**METROPOLITAN GOVERNMENT OF NASHVILLE AND DAVIDSON COUNTY**

**STAFF RECOMMENDATION**  
**2619 Essex Place**  
**November 14, 2012**

**Application:** New construction –addition  
**District:** Hillsboro-West End Neighborhood Conservation Zoning Overlay  
**Council District:** 18  
**Map and Parcel Number:** 10411026600  
**Applicant:** Ben Mosley  
**Project Lead:** Michelle Taylor, michelle.taylor3@nashville.gov

Rear façade of the existing house. Sunroom and deck to be demolished and replaced with new screened porch with enclosed stairs.

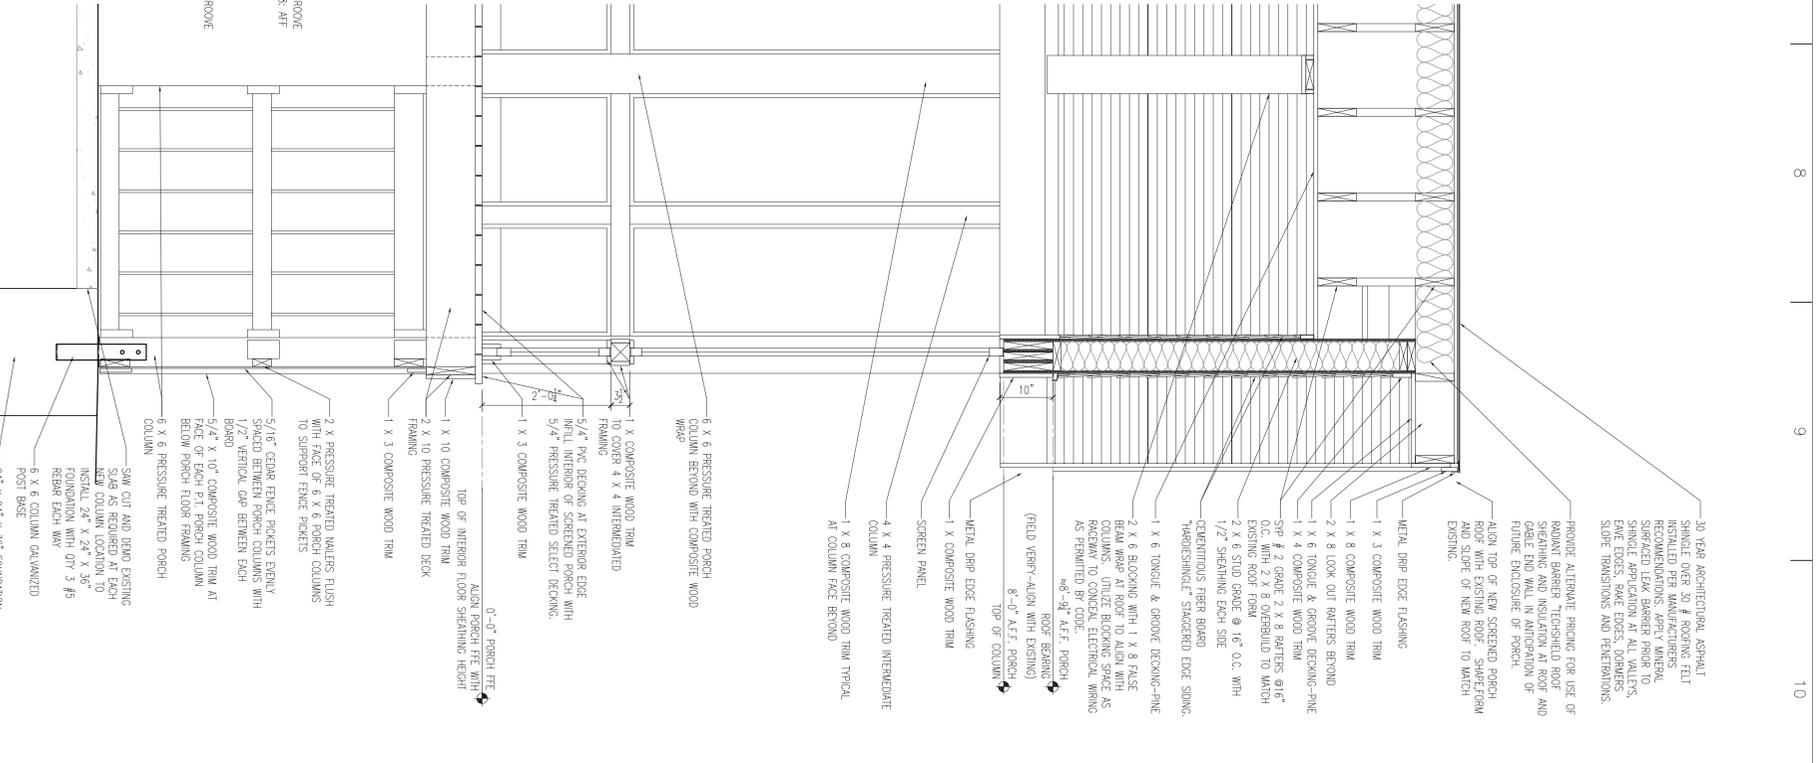
Demolition: The applicant is proposing to demolish an existing sunroom and deck which will involve demolishing and reconstructing approximately nineteen feet (19') of rear wall associated with a previous addition. Staff finds that the demolition of this portion of the house meets the design guidelines because it does not contribute to the historical or architectural character of the house. Staff therefore finds that the removal of the back portion of the house meets Section III.B. of the *Hillsboro-West End Neighborhood Conservation Zoning Overlay: Handbook and Design Guidelines*.

**6F**  
FRONT/STREET ELEVATION  
1/4"=1'-0"

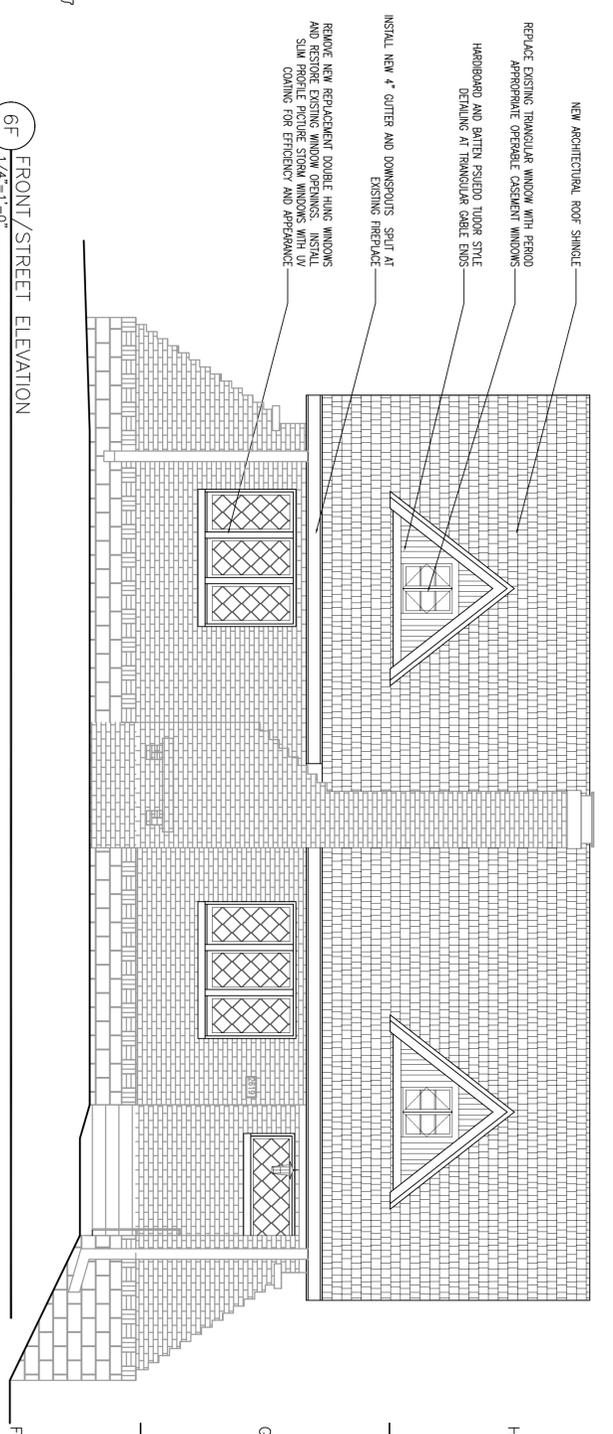
Materials, Texture, and Details and Material Color: On the front façade, the applicant proposes to remove replacement windows obscuring the existing diamond lite decorative windows. In addition, new operable windows will be installed in the existing second story gables on the front façade. The roof will be replaced with an architectural asphalt shingle roof. The existing vinyl siding, trim wrap, gutters, and downspouts will be removed. The siding on the existing house including the existing addition will be replaced with cement fiber half-timbering and shingles with 5/4 inch composite wood trim.

With the staff's final approval of the roof color and window specifications, staff finds the proposed materials to meet Sections II.B.1.d. and II.B.2. of the *Hillsboro-West End Neighborhood Conservation Zoning Overlay: Handbook and Design Guidelines*.

**Recommendation Summary:** Staff recommends approval of the addition with the following condition: Staff review and approve the color of the roof shingles if they are not to match the existing and the window specifications prior to purchase and installation of these materials.

**1E**  
REAR ELEVATION  
1/4"=1'-0"

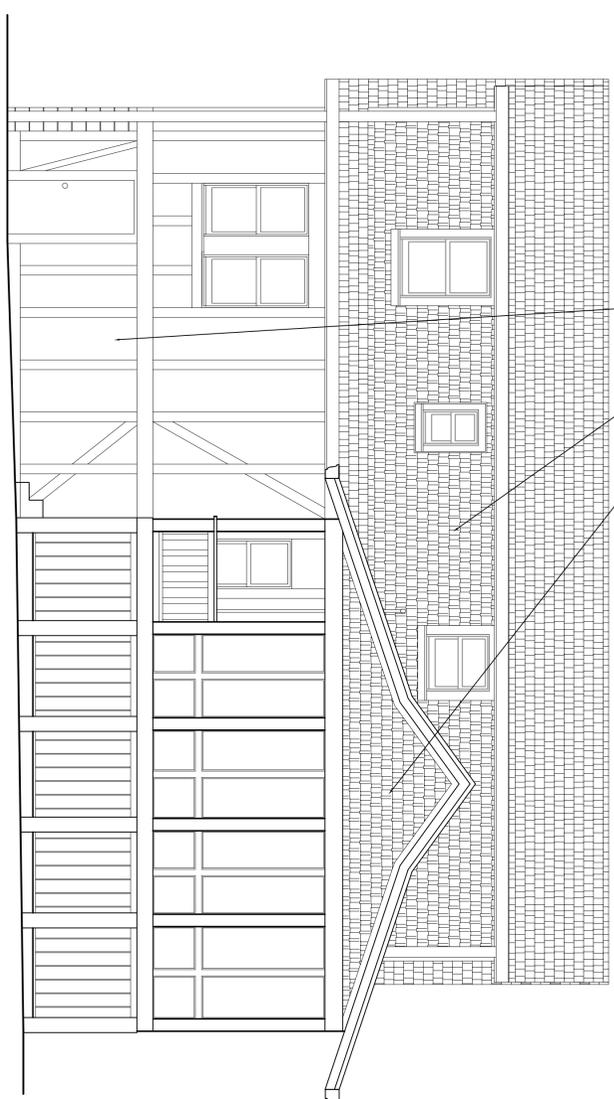
Roof: The historic house's primary roof form is a side-gable. The roofline of the new screened porch will be a rear gable in continuation of the existing single story addition.

Proportion and Rhythm of Openings: The addition will be screened on all outwardly facing facades. Staff therefore finds the project's proportion and rhythm of openings to meet Sections II.B.1.g. and II.B.2. of the *Hillsboro-West End Neighborhood Conservation Zoning Overlay: Handbook and Design Guidelines*.
